SOUTH HOLLAND DISTRICT COUNCIL

Advertisement Consent

Reference: H16/0519/94 Received:28-JUN-94 Type:ADVERTISEMENT

Description: Replacement fascia sign and projecting bracket sign

SIGN 'A'

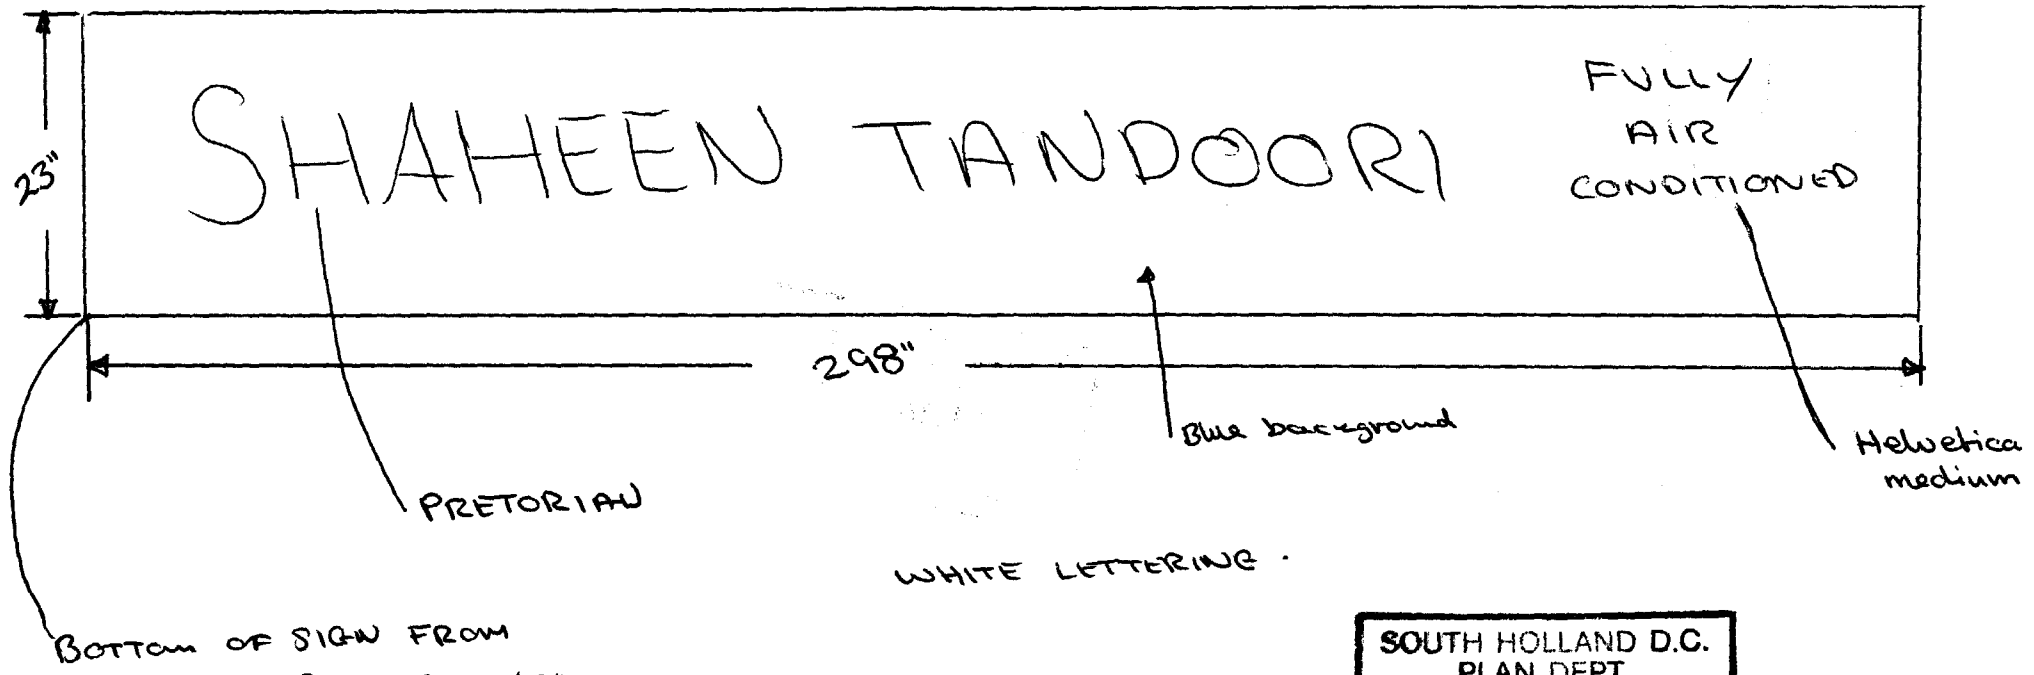
3 The replacement fascia sign fronting Pinchbeck Road shall be constructed in such a way to ensure that the Blue background panel remains non-illuminated and only the individual letters of the advertisement are illuminated.

all as existing Sign (BUT BACKGROUND IS TO BE BLUE)
